## 10.0 Steam and Power Conversion System

The information in this section of the reference ABWR DCD, including all subsections, tables and figures, is incorporated by reference with the following departures and supplements.

Figure 10.1-1 Reference Steam and Power Conversion System

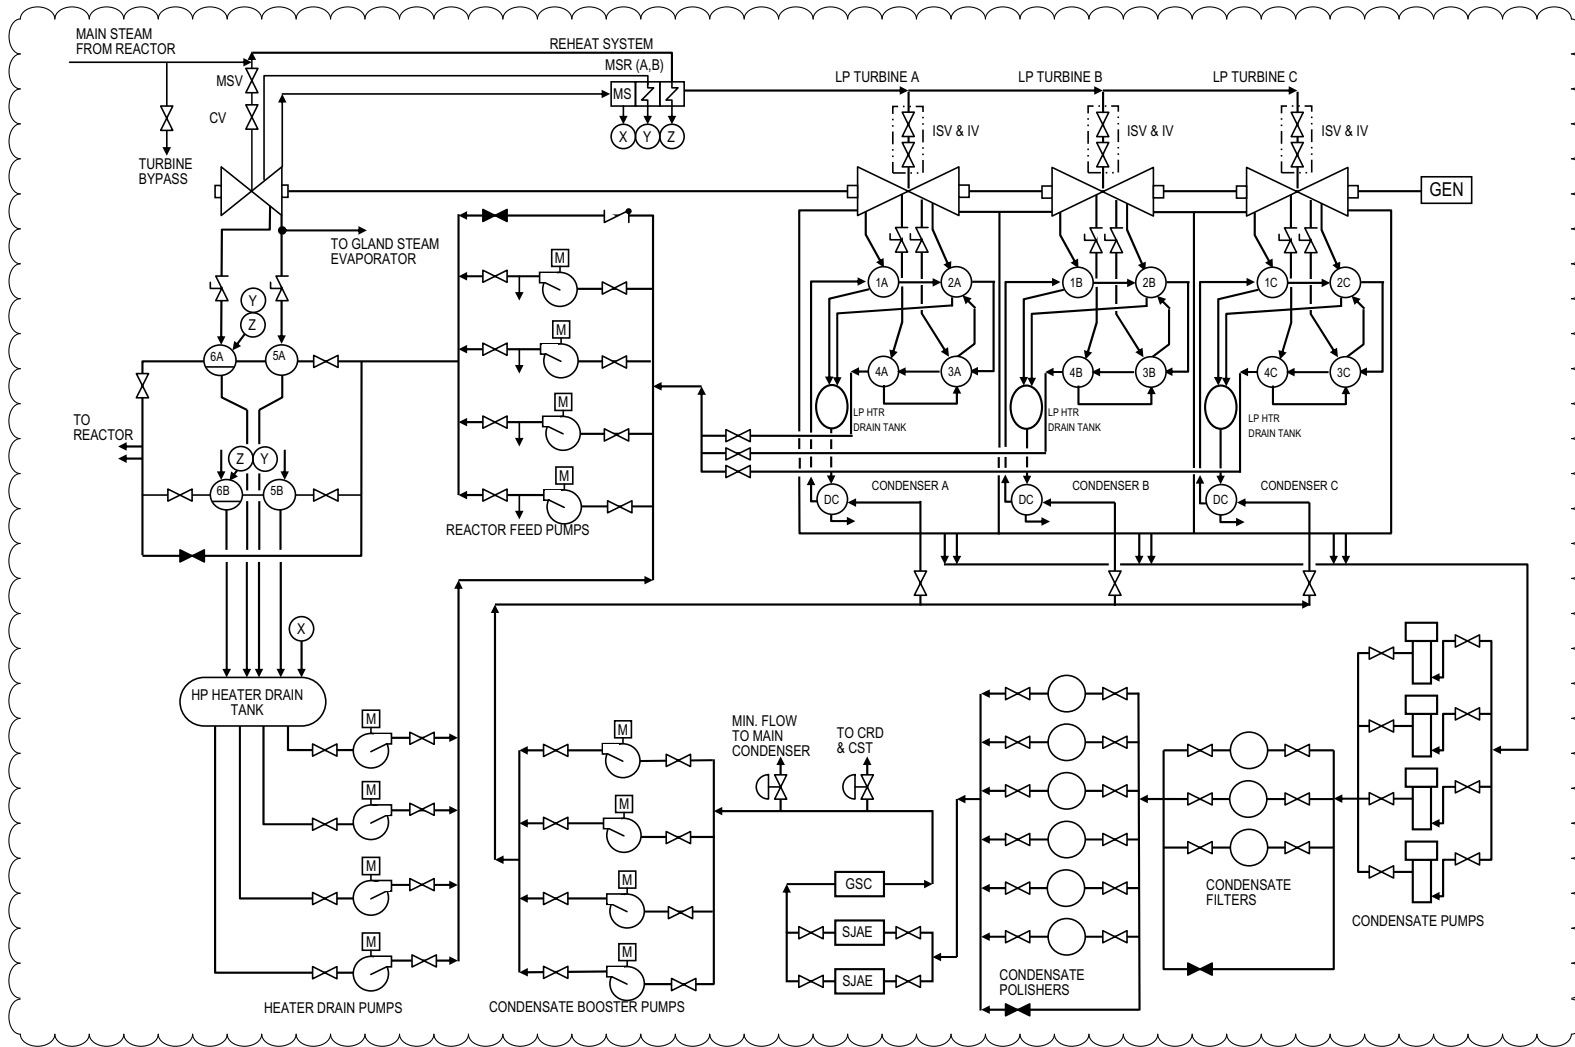
STP DEP 9.2-3 (Figure 10.1-1)

STP DEP 10.1-2 (Figure 10.1-1)

STP DEP 10.2-1 (Table 10.1-1, Figure 10.1-1)
